ENVIRONMENTAL REVIEW TEAM REPORT

SALEM ROAD WETLAND PROSPECT ,CONNECTICUT KING'S MARK

**SALEM ROAD WETLAND
APRIL, 1984**

FIGURE 1 TOPOGRAPHIC MAP

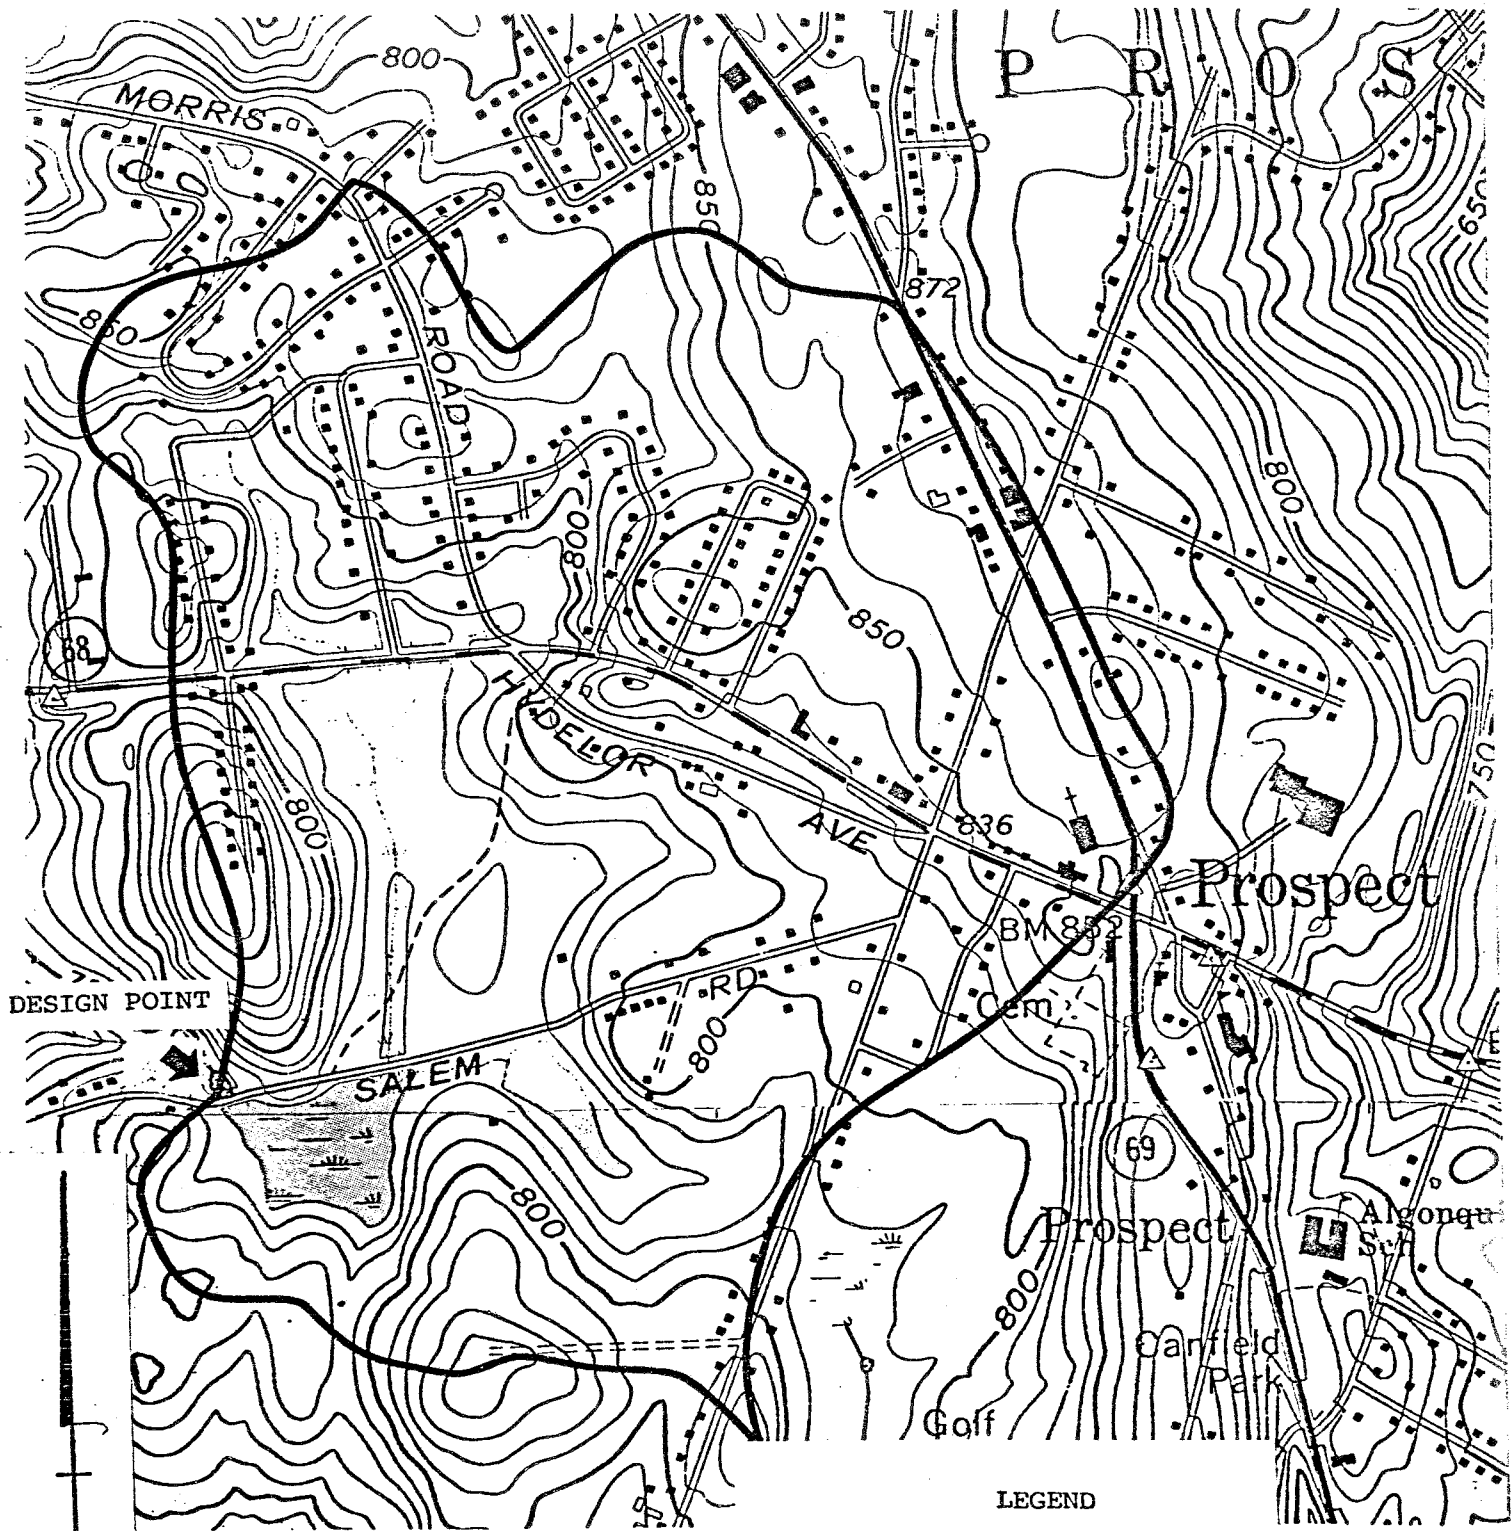
By definition, the watershed for the Salem Road Wetland comprises all land areas from which water may drain into the wetland. A raindrop falling on the watershed boundary would have a 50 percent chance of passing into or out of the watershed. Figure 1 shows the watershed boundaries, which tend to follow the crests of local hills. The watershed, as delineated, comprises approximately 520 acres (about .8125 square miles).

FIGURE 2 CONCEPTUAL SITE PLAN

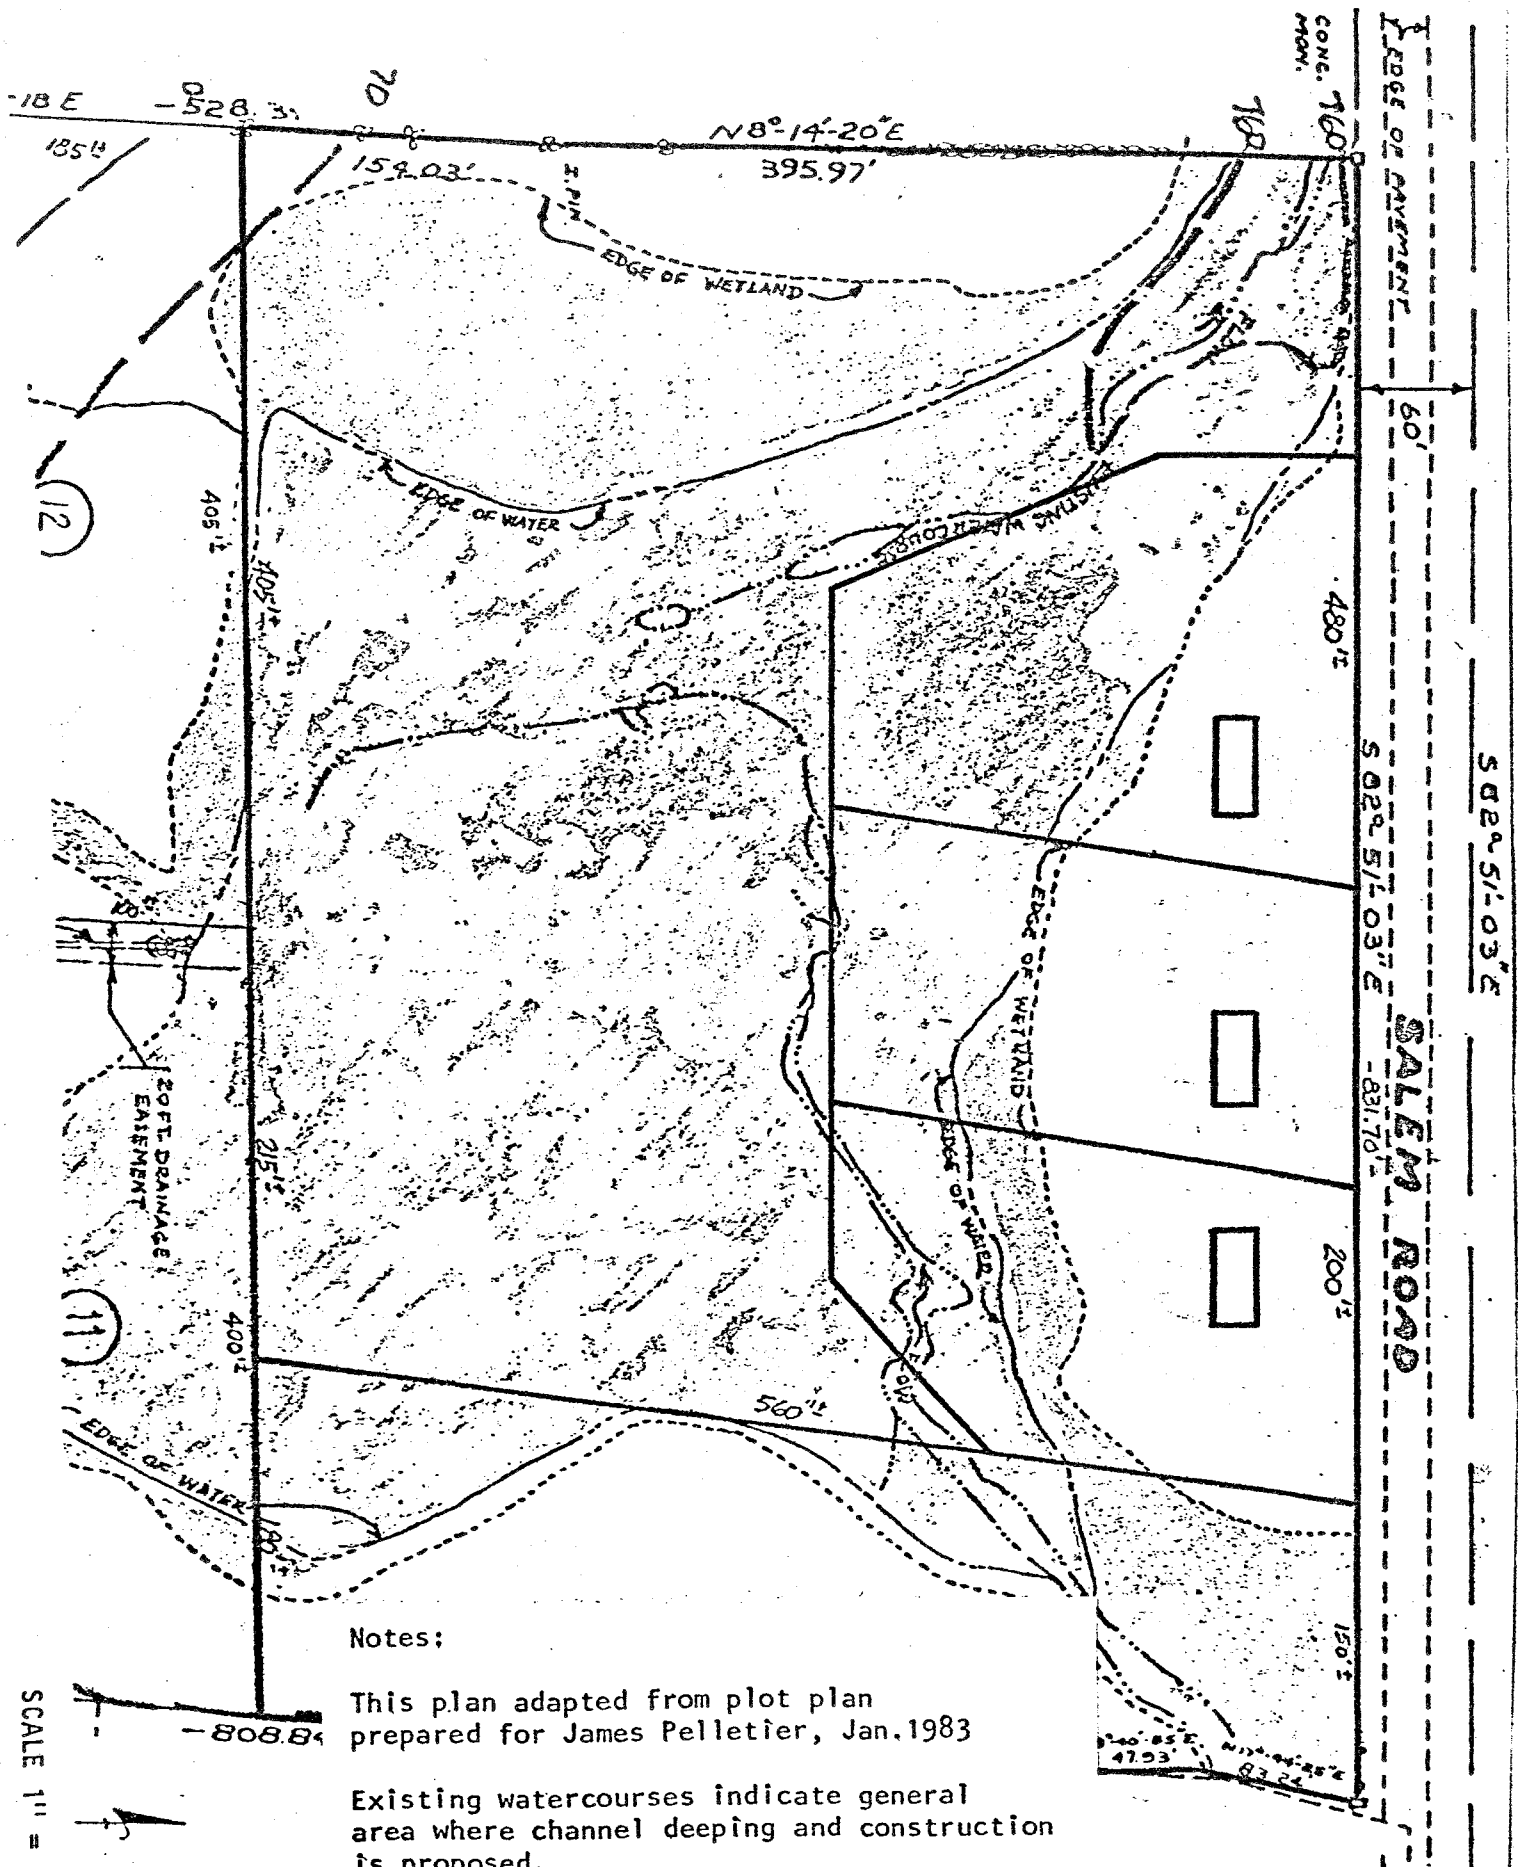
The landowner of the Salem Road wetland is interested in "cleaning out" and deepening the brook traversing this area. This activity is being proposed in order to "dry out" the back yard areas of several recently approved homesites along Salem Road, and to minimize potential flooding in the area. No detailed plan for the project has yet been submitted, but a conceptual plan for the activity is portrayed in Figure 2.

Some of the hydrological and ecological effects that may occur in the wetland if the channel is "deepened" as planned include: 1) by increasing the velocity of the stream, particularly during high flows, there is the potential for increasing flooding downstream; 2) due to increased stream velocities, there will be a potential increase in stream bank erosion, at least initially; 3) reducing the pollution filtering capabilities of the wetland through most of the year (except springtime) which would lead to increases in sediment and nutrient loads downstream; and 4) damage or destruction to wildlife habitats and wetland vegetation.

In view of the valuable hydrologic and ecologic functions of the Salem Road Wetland, it appears that the proposed deepening of the channel in this area could have significant negative impacts on existing conditions and downstream properties. Based on visual inspection of the backyard areas of the

Mr. Pelletier has also expressed an interest in lowering the culvert under Salem Road which drains his wetlands and/or adding additional barrels for drainage. In this regard it should be noted that the lower reaches of Fulling Mill Brook flows through the highly developed center of the Town of Naugatuck. The 12 acre wetland on Mr. Pelletier's property, situated as it is at the top of the Fulling Mill Brook watershed, is ideally suited to mitigate flood flows through this urban center, and in fact, is currently providing that function. Due to this important flood mitigating function, the Team's engineer would not recommend lowering the culvert under Salem Road or adding additional barrels. To do so would seriously alter the highly valuable flood storage characteristics of the wetland.

To conclude, the proposed lowering of the culverts on Salem Road and dredging of the brook bottom can be expected to have a number of significant adverse environmental effects, the most significant of which is the lessening of the flood storage capacity of the Salem Road wetland. While the project could be expected to lower flood elevations within the Salem Road Wetland during high flow periods, the project would, at the same time, increase the potential for additional flooding downstream. In other words, the flooding "problem" would simply be transferred further downstream. It should also be noted that deepening of the channel in the wetland without lowering the culverts under Salem Road is not expected to have a significant effect in drying out the edges of the wetland. It is the high groundwater table rather than the brook proper which is maintaining the wetland.

The proposed brook deepening would take place in the area of the Carlisle soils. As stated above, excavation would be difficult even during dry summer months. Finding firm mineral material for a channel bottom and side slopes may also be difficult. The brook is mapped as a perennial stream. Close attention to sediment and erosion control measure planning and installation would be extremely important if channel deepening were to occur. An excavated pond exists downstream from the proposed activity. Sediment could be deposited in this pond if proper measures were not installed. Measures may include sediment basins, silt fencing and staked haybale filters.

In regard to cleaning the channel of debris (i.e., broken limbs, fallen trees, material from upstream areas, etc.), it was the opinion of Team members during the field review that there would be no harm provided it is done manually and not with heavy equipment.

An alternative to deepening the channel may be to clear it of vegetative obstructions such as fallen trees, branches, and stumps. Large, heavy equipment will have difficulty gaining access to the stream channel. Clearing the existing channel may best be accomplished by manpower and small handheld power equipment. Access to the stream can be gained more easily when the ground is frozen or in the dry summer months. Erosion and sediment transport can be kept to a minimum at this time also. Silt fence should be placed across the stream before any activity in the stream begins. The fencing should remain until all activity has been completed. The fencing should be properly maintained by removing any large obstructions that may inhibit its filtering capacity.

It seems, then, that the proposed channel deepening would have substantial adverse ecological impacts that would be difficult, if not impossible, to mitigate. In light of this, the Team's biologist suggests that serious consideration be given to abandoning the plan to deepen the channel. Removing dead trees and shrubs from the channel area should not cause significant problems provided this work is done manually. The area simply is not suitable for the use of heavy equipment. If the channel deepening is conducted despite the above suggestions, then the excavation activities should begin upstream and proceed downstream, so that sediments released by the activity will be removed as the excavation proceeds. All work should be conducted during low-flow periods.

FIGURE 4 FLOOD HAZARD AREAS

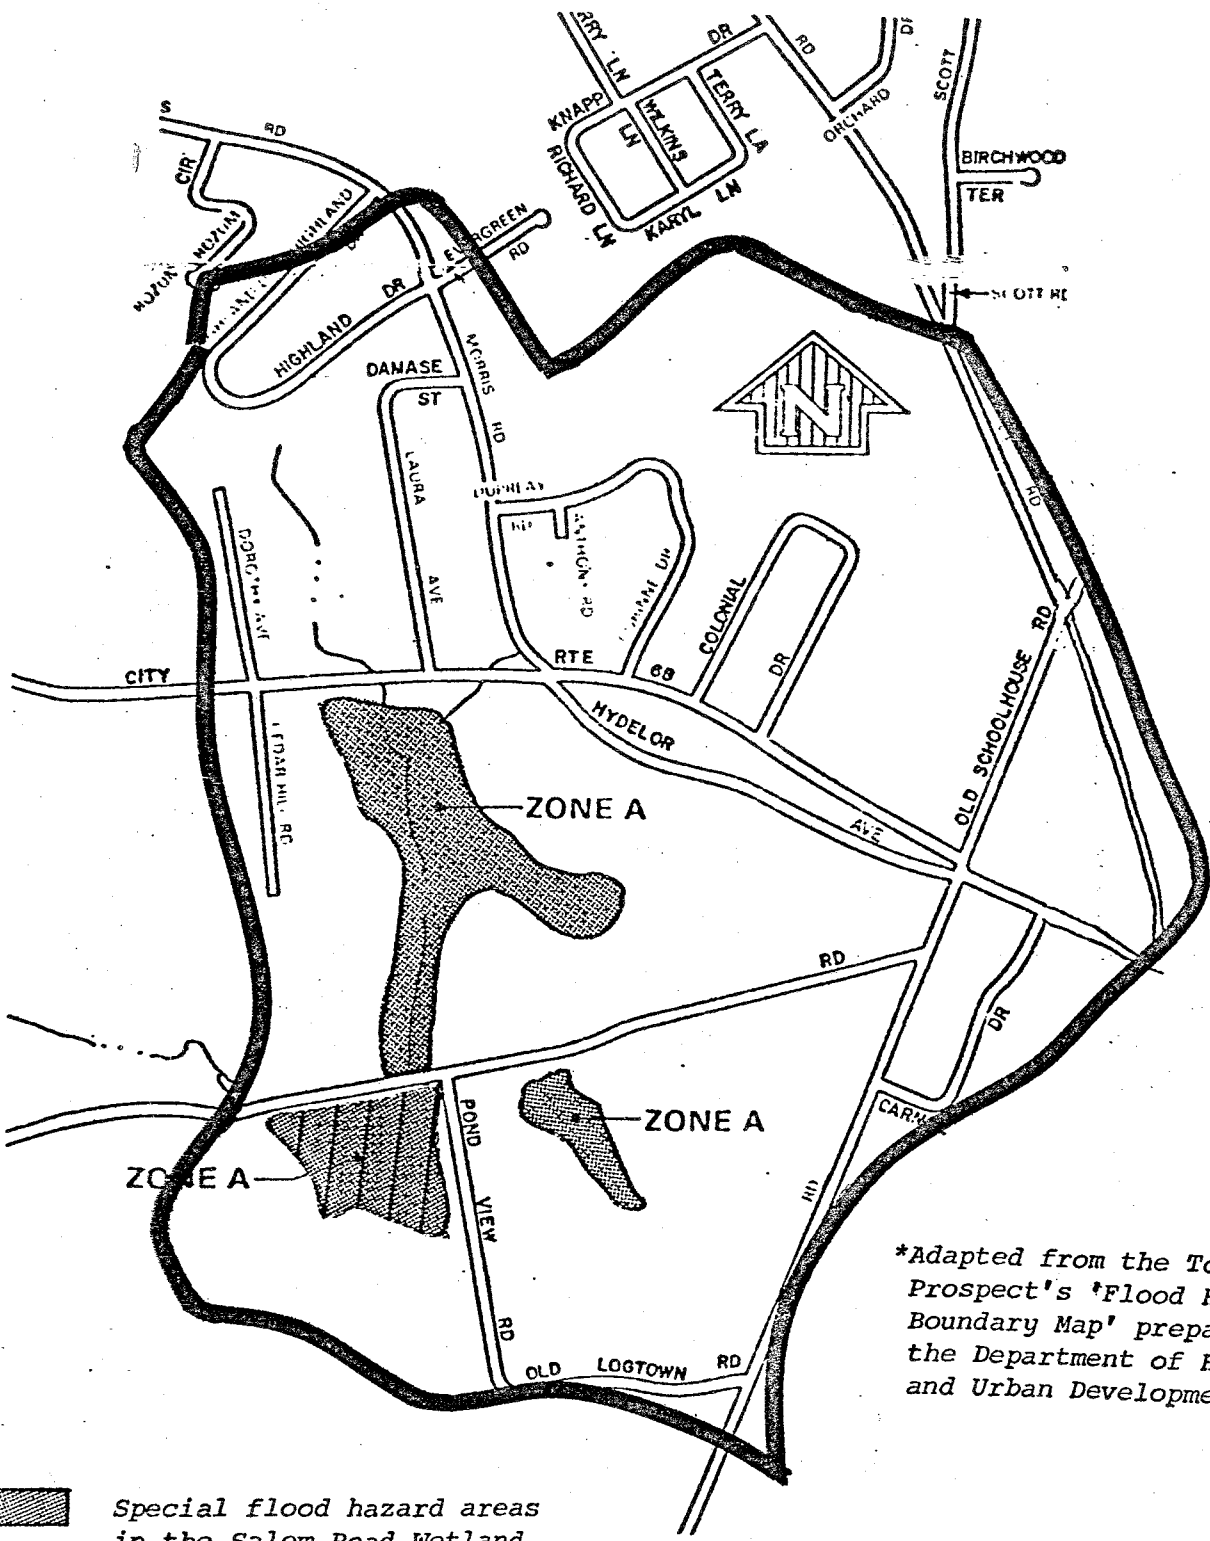
The Department of Housing and Urban Development has prepared a Flood Hazard Boundary Map for the Town of Prospect. Based on this map, the Salem Road Wetland area, the wetland areas bisecting the watershed north of the study area, and the low-lying area surrounding the pond east of the Salem Road Wetland all lie within special flood hazard areas (see Figure 4).
